**#2021-117**

## **Walmart Final PUD Amendment**

### **Project Review for Planning and Zoning Commission**

Final Planned Unit Development Amendment to allow exterior changes to the building façade with an additional sign variation for increased signage, a building addition and changes to the site for a new fulfillment pickup area.

SHEET:  
A2

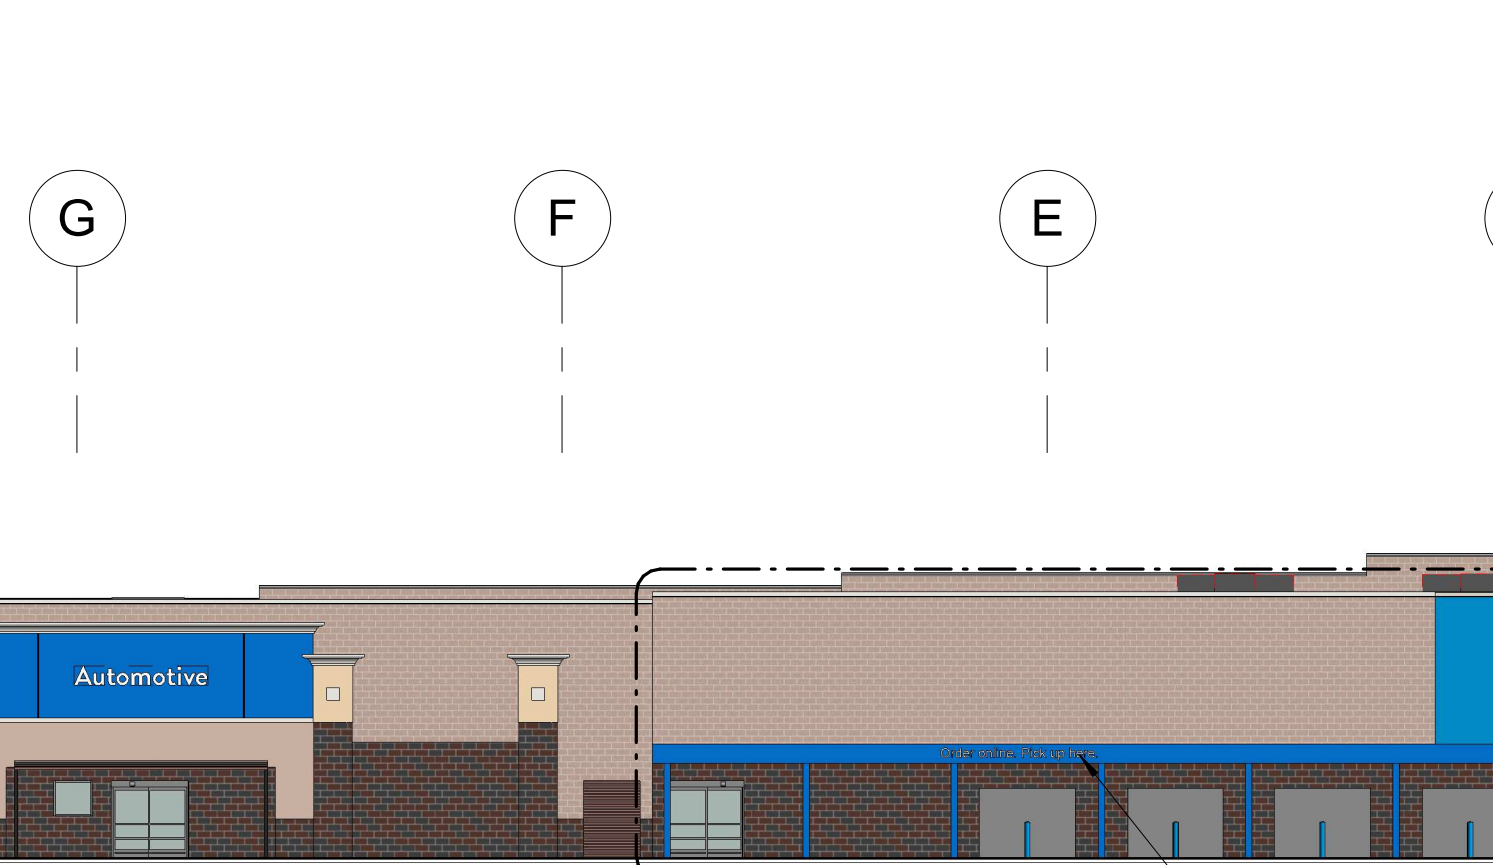
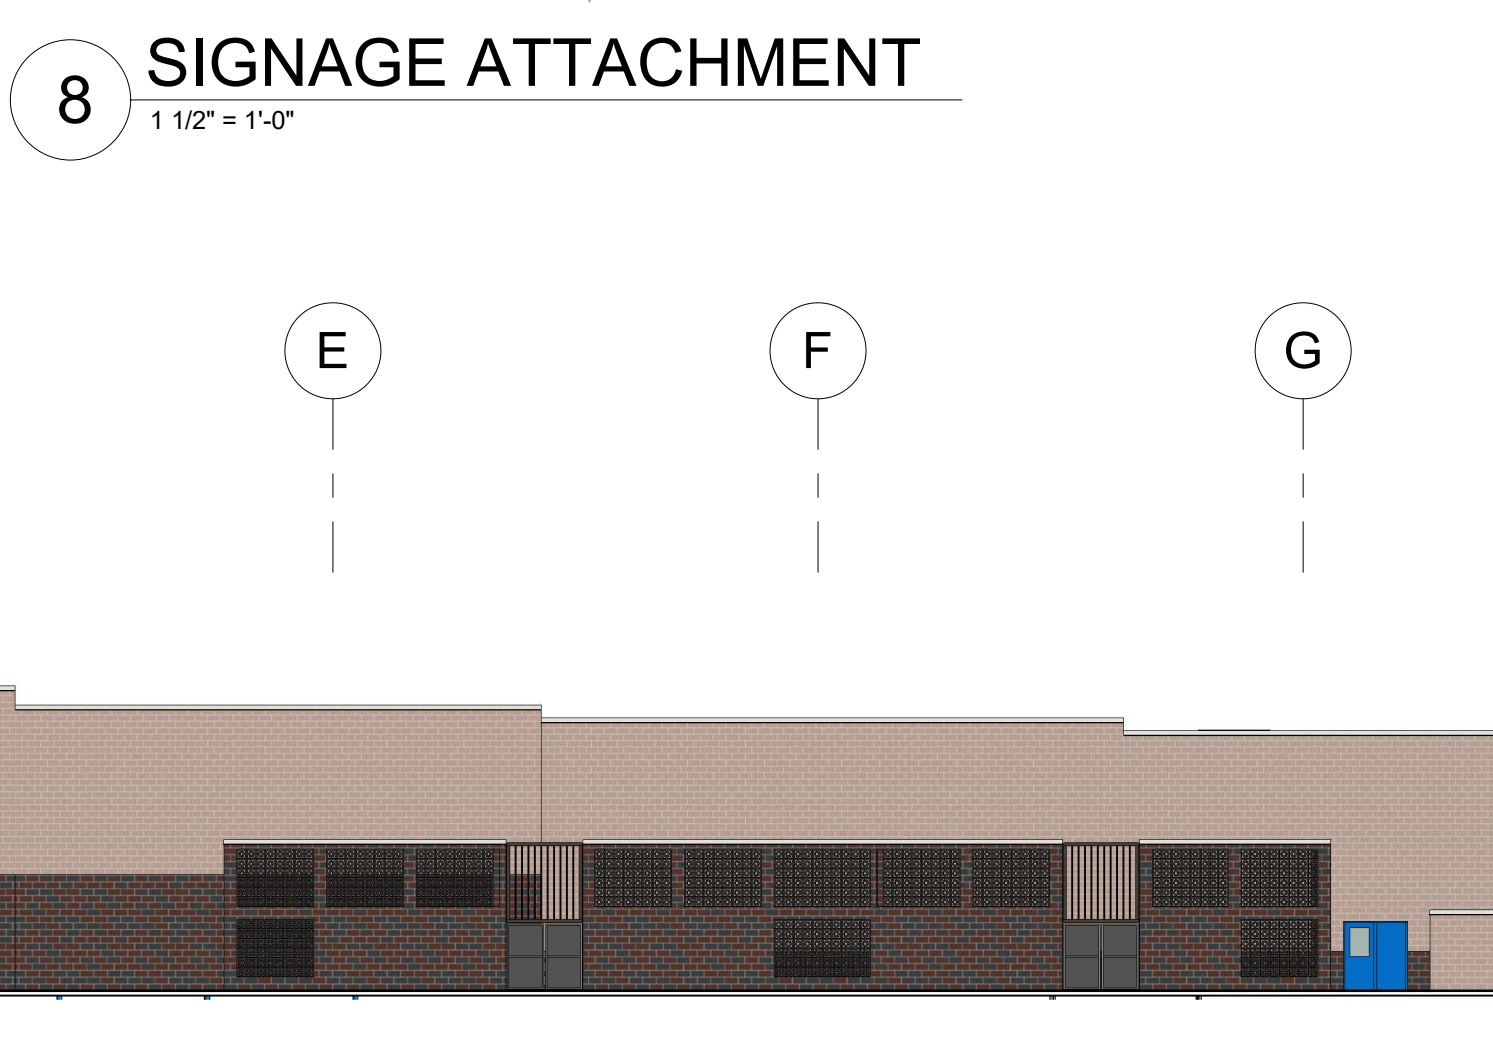
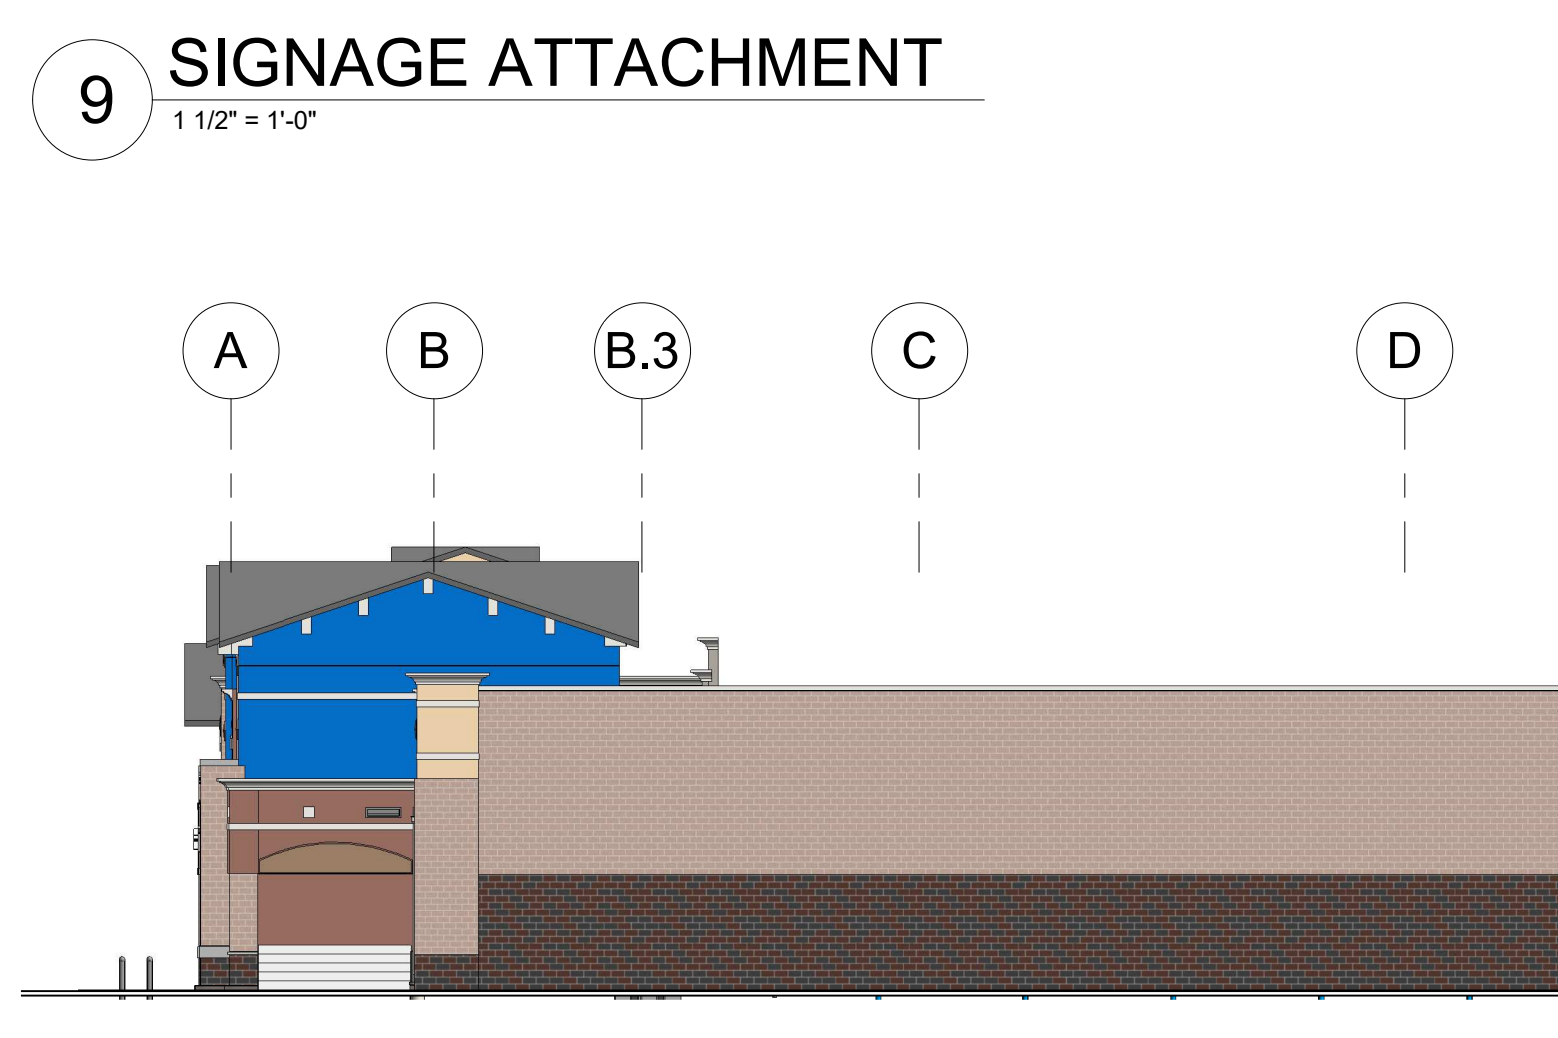
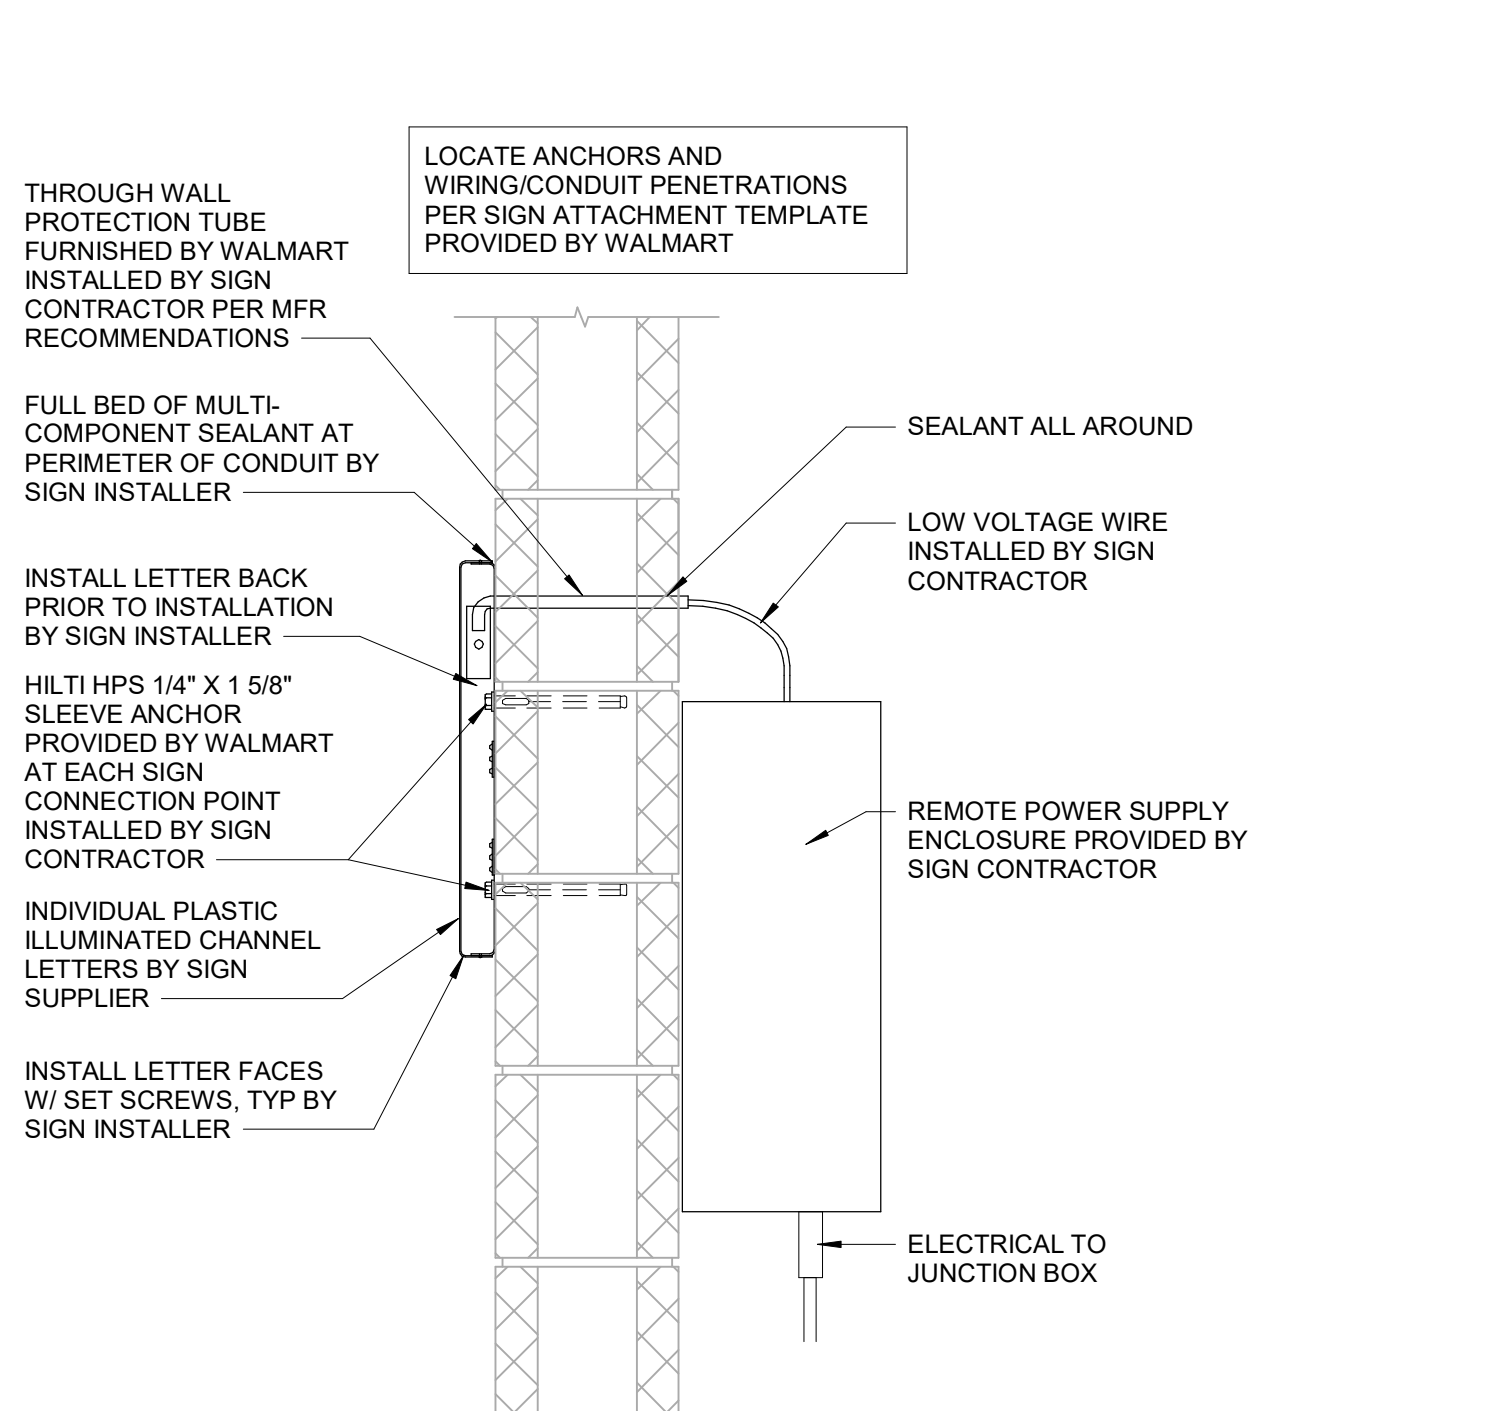
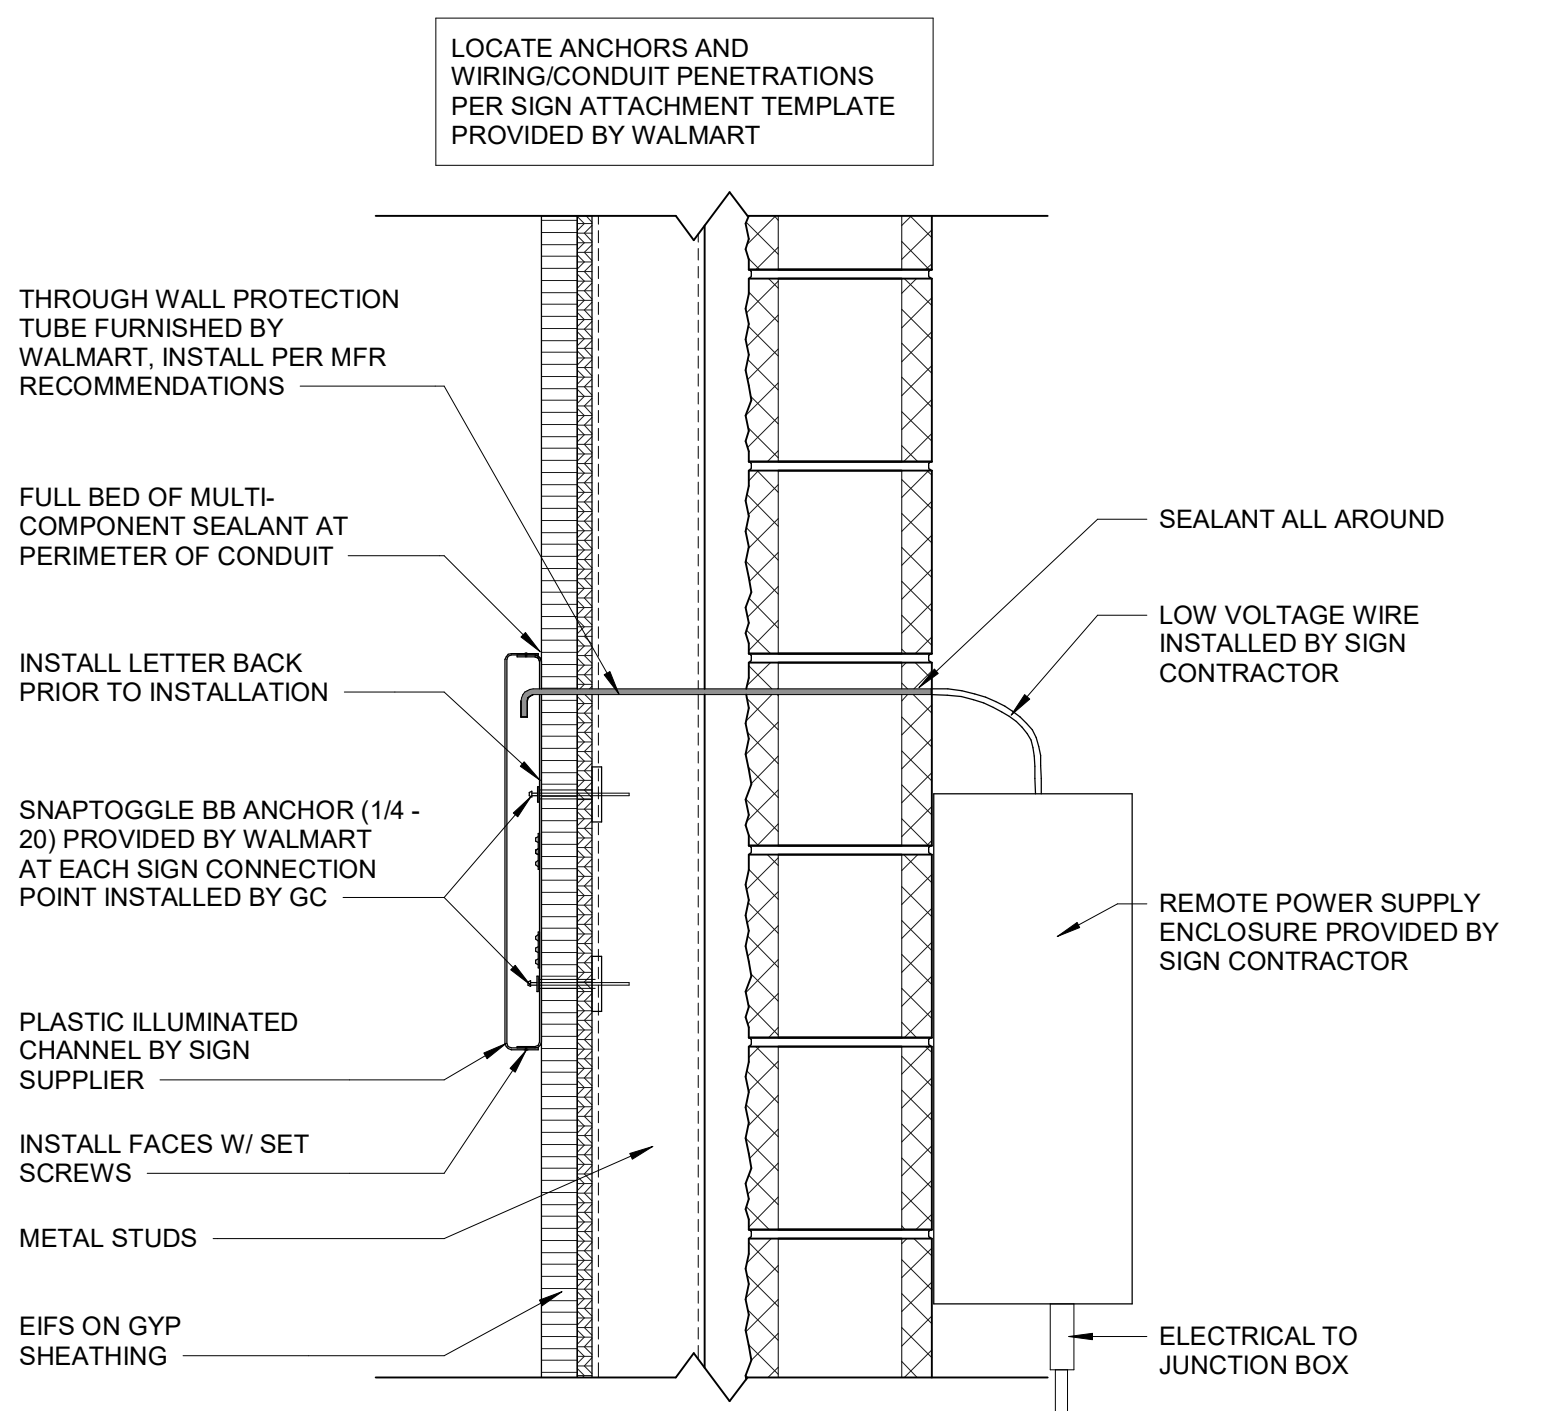
- A small addition is added to the north side of the building, with all exterior materials and colors matching the existing façade appearance.
- A blue canopy with signage will help direct customers to this location.
- Staff is recommending adding a white top cap and step down architectural feature around the “Pickup” sign similar to the “Automotive” sign.

- The blue canopy contains two “Order online, Pick up here” signs. Each sign is 22 square feet for a total of 44 square feet.
- A new Pickup sign will be installed above the canopy area. This wall sign is only 32.37 square feet in area, but the entire blue box is calculated and that size is 350 square feet.
- The signage schedule lists a new total building signage of 455.56 square feet that does not include the entire blue box. Figuring the total existing and new signage with the blue box equals 773.19 square feet of signage.
- Some pick up signage from the front elevation is being removed and the inclusion of the entire blue box is a net increase in 351.89 square feet of signage.

The way signage is calculated, it includes painted areas like the blue background. Although the text portion of the sign area is only 32.37 square feet, the calculated signage is 350 square feet. The petitioner can request this variation as part of the PUD approval.

1. Approved plans, reflecting staff and advisory board recommendations, as approved by the City Council:
  - A. Application (Rico, received 07/29/21)
  - B. Elevations, [sheet A2, A2.1, Rendering] (pb2 Architecture+ Engineering, dated 06/18/21, received 07/12/21)
  - C. Site Plan (Carlson Consulting, dated 06/18/21, received 07/12/21)
2. Work with staff to replace any dead or dying landscape on the Walmart site.
3. Create a white cornice cap over the "Pickup" area, similar to what is found over the "Automotive" area.
4. Stripe the new customer pickup parking spaces at 19 feet long.
5. The petitioner must address all of the review comments and requirements of the Community Development, Fire Rescue, Police, and Public Works Departments.
